Semiconductor Products Sector  
Engineering Bulletin

**EB381**

## **Migrating from the MC68HC811E2 to the MC68HC11F1**

Figure 1. Pin Assignments for MC68HC11F1 68-Pin PLCC

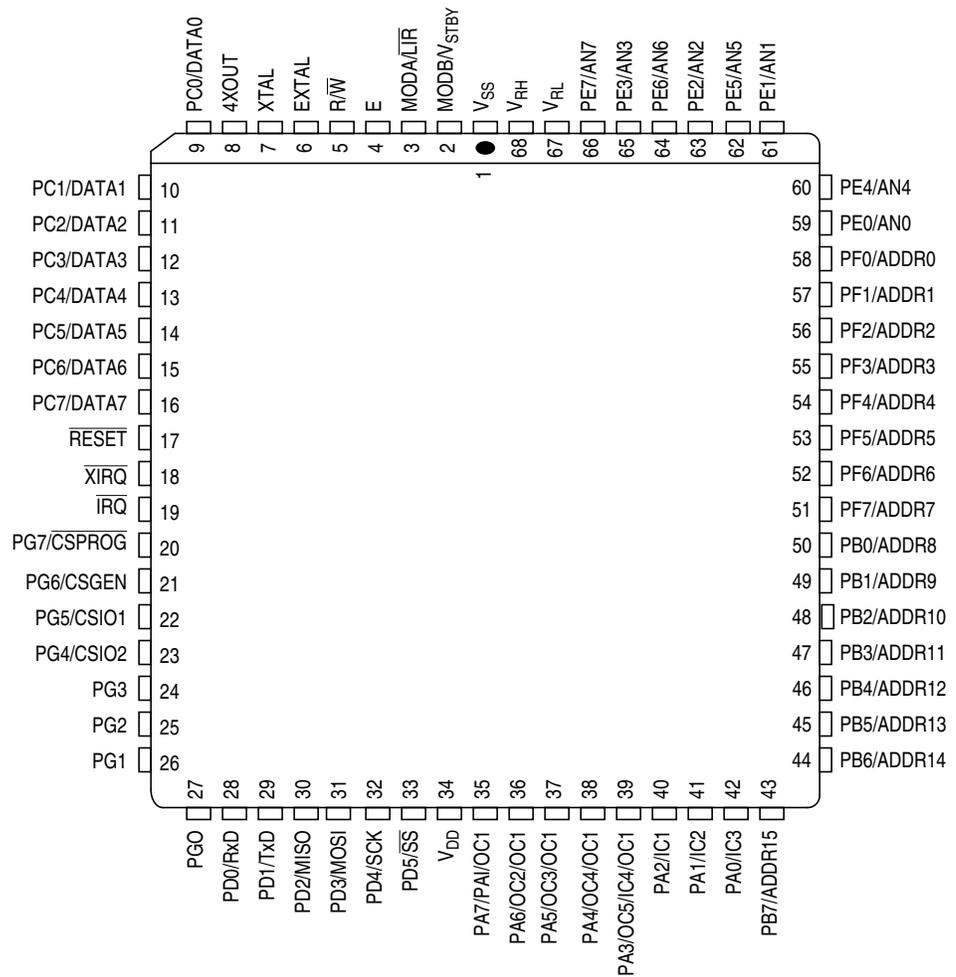
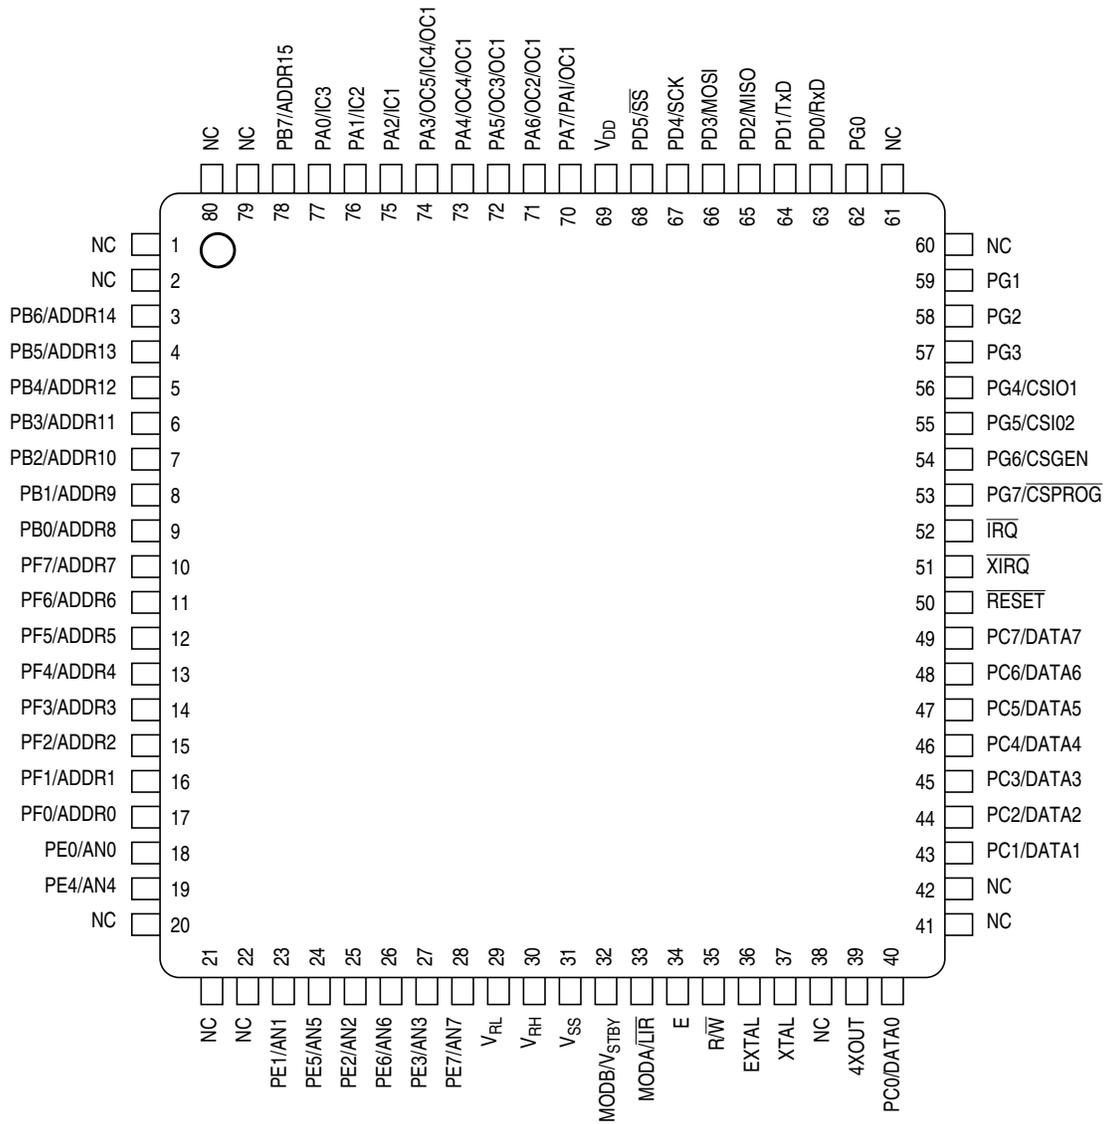
Example: 52-pin PLCC  
 Issue: Only 68-pin PLCC or 80-pin LQFP available  
 Change required: Re-layout application to allow use of the 68-pin PLCC or the 80-pin LQFP. See [Figure 1](#) and [Figure 2](#).

Change required: Re-layout application to allow use of the 68-pin PLCC or the 80-pin LQFP. See [Figure 1](#) and [Figure 2](#).

**Figure 4. MC68HC11F1 Memory Map**

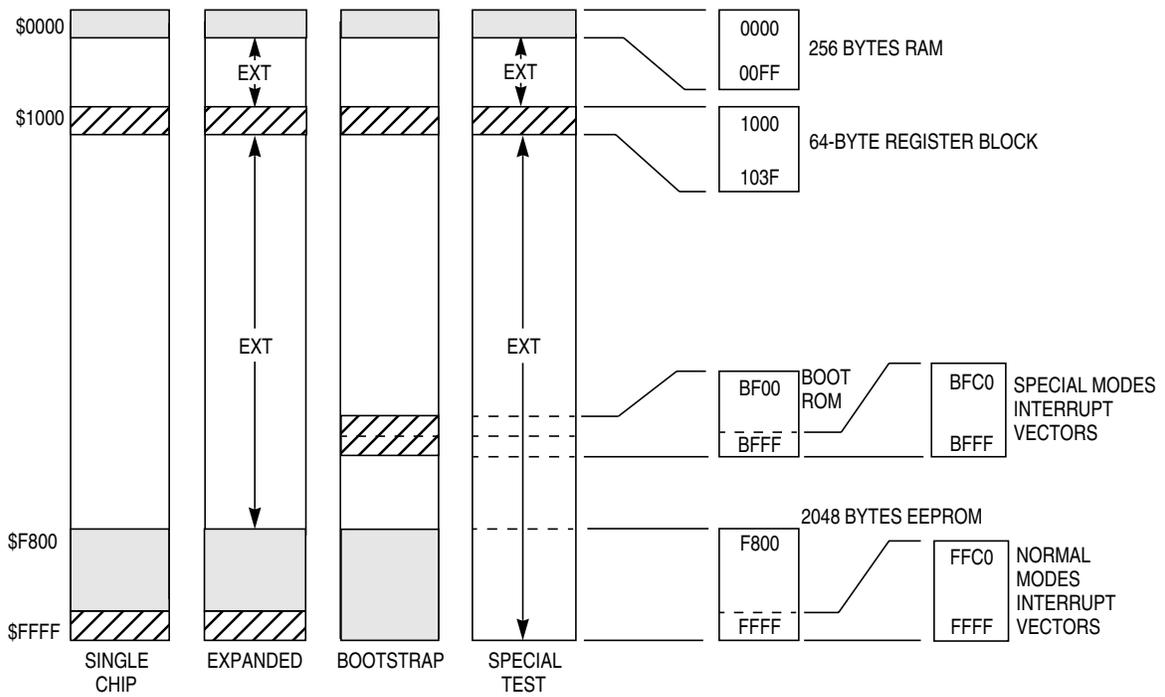
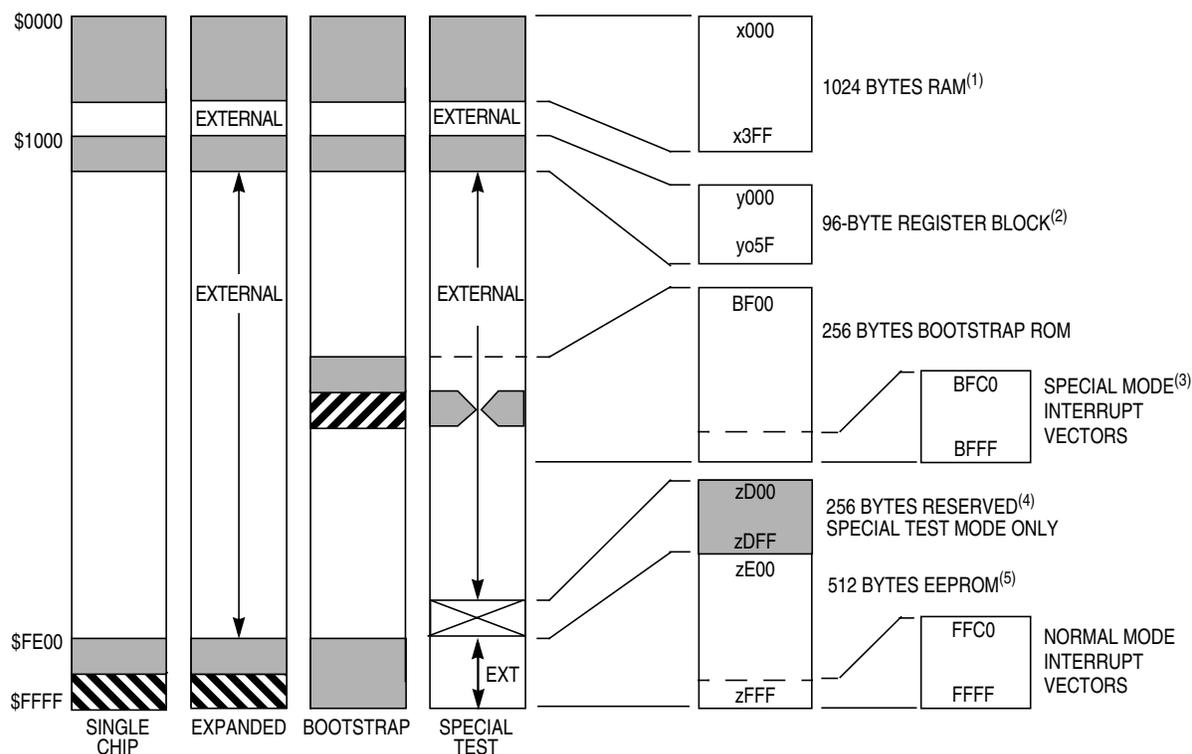
The MC68HC811E2 has the same memory mapped locations for the normal mode interrupt vectors. The RAM, EEPROM, external addressing, and registers for these devices are different. See [Figure 3](#) and [Figure 4](#).

Issue: The MC68HC11F1 has less EEPROM (512 bytes vs. 2048 bytes), and it is located at a different starting address (\$FE00 vs. \$F800).

Issue: External address range is different.

Issue: Register block is a different size and some register addresses have different meanings.

Change required: Change code to use new EEPROM block located from \$FE00 to \$FFDF.

Change required: Change the external address range from \$1040–\$F7FF to \$1060–\$FDFF.

Change required: The register block on the MC68HC11F1 is 96 bytes instead of 64-bytes and is located at a default location of \$1000–\$105F. This block of RAM is also re-locatable on 4-K boundaries in the 64-Kbyte address space by writing to bits 0–3 in the INIT register. These register addresses also have different meanings: \$1001, \$1002, \$1003, \$1005, \$1006, \$1036, \$1038, and \$103E. \$105C–\$105F are additional registers.

**Figure 5. Block Protect Register (BPROT)**

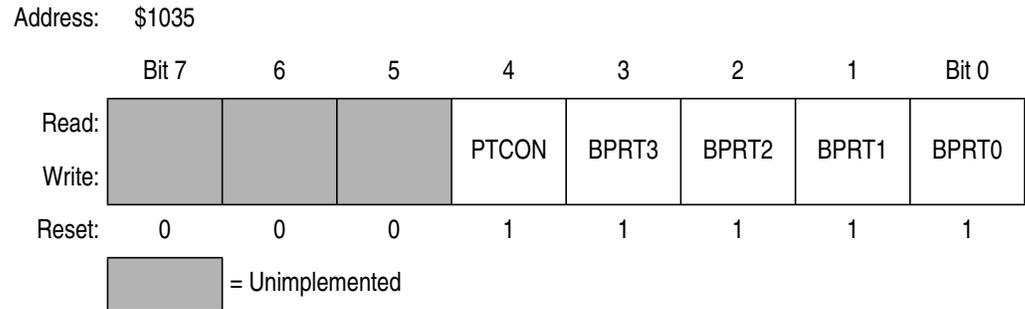
- Example: EEPROM block protect
- Issue: EEPROM block protect addresses and sizes are different.
- Change required: The BPRT bits in the BPROT register (\$1035) must be changed to protect the address ranges and block sizes the user desires.

**Figure 7. M68HC11F1 System Configuration Register (CONFIG)**

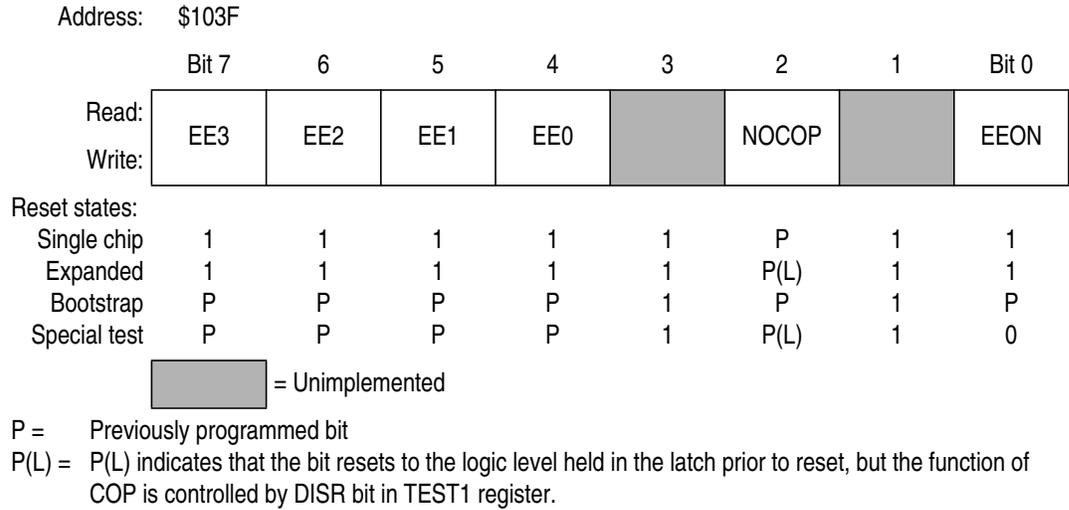
Issue: Some of the bits in the CONFIG register have different meaning.

Change required: The bits in the CONFIG register (\$103F) must be changed to meet the user's requirements. Bit 3 (NOSEC) is not used and bits 4–7 (EEPROM mapping) define different address ranges.

**Figure 10. MC68HC11F1 Expanded Mode Memory Map Example**

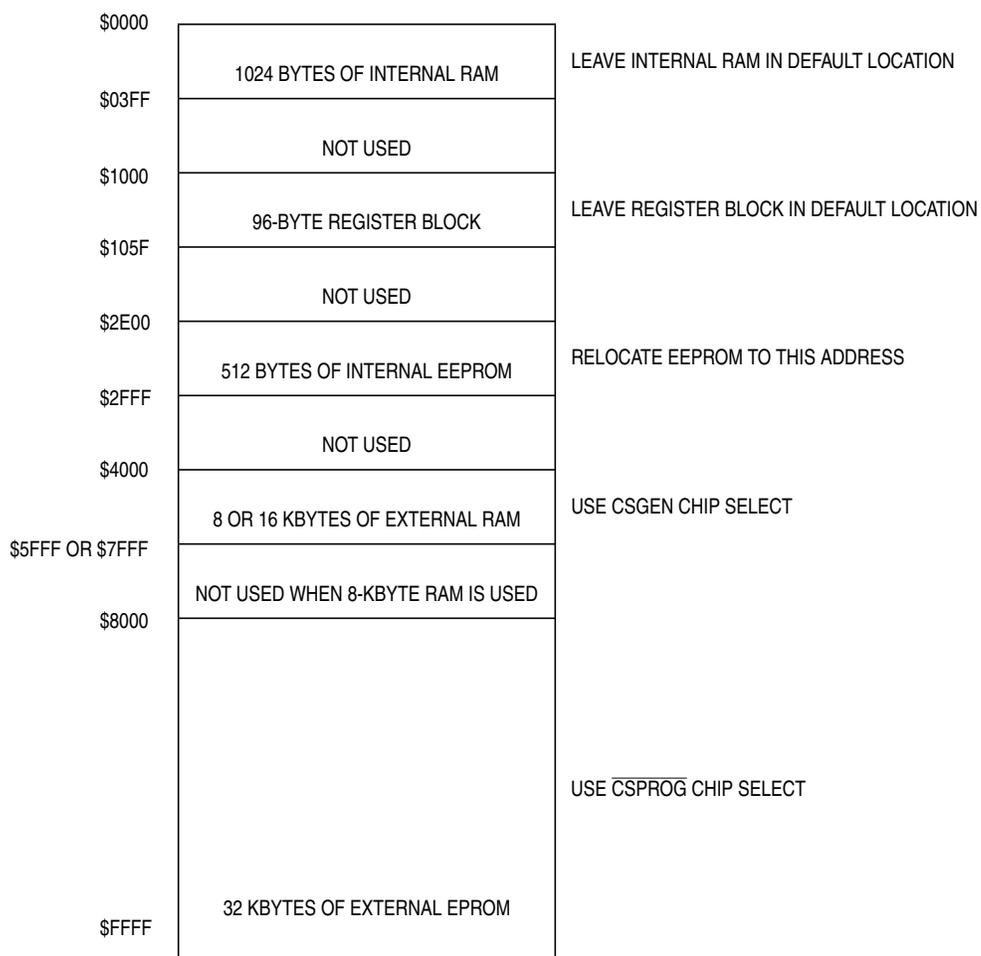
This example is for connecting an 8- or 16-Kbyte external RAM and a 32-Kbyte external EPROM. See [Figure 10](#).

- Leave internal RAM at default location (\$0000–\$03FF).
- Leave register block at default location (\$1000–\$105F).
- Relocate internal EEPROM to address \$2E00–\$2FFF. This is done by programming the EE0–EE3 bits in the CONFIG register (\$103F) to %0010. You may also need to program the EEON bit to ensure that the EEPROM is present in the memory map (see [Figure 7](#)).
- $\overline{\text{CSPROG}}$  comes up enabled in expanded mode. You will need to program the PSIZA and PSIZB bits in the CSCTL register (\$105D) to set an address range. In this example, PSIZA = 0 and PSIZB = 1 (\$8000–\$FFFF). The user may also want to clear the PSTHA and PSTHB bits in the CSSTRH register (\$105C) to ensure no clock stretch is used. Another option with  $\overline{\text{CSPROG}}$  is the priority regarding CSGEN. This can be programmed using the GCSPR bit in the CSCTL register.

- For the CSGEN chip select, the G1SZA–G1SZC bits in the CSKSIZ register (\$105F) must be programmed to %011 for an 8-Kbyte RAM or to %010 for a 16-Kbyte RAM.

- Next, the starting address for this address must be programmed. This is done by programming bits GA13 and GA15 for the 8-Kbyte RAM or bits GA14 and GA15 for the 16-Kbyte RAM. Like the CSPROG, clear the GSTHA and GSTHB bits to disable the clock stretch.

- The user should also set the GNPOL bit (bit 4) in the CSKSIZ register to a 0 to make sure chip select CSGEN is an active low. Normally, the chip select for an external RAM device is made active with respect to the E clock going high. In this example, the CSGEN chip select needs to be made active during the address valid time. This is done by setting the GAVLD bit (bit 3) in the CSKSIZ register to a 1.
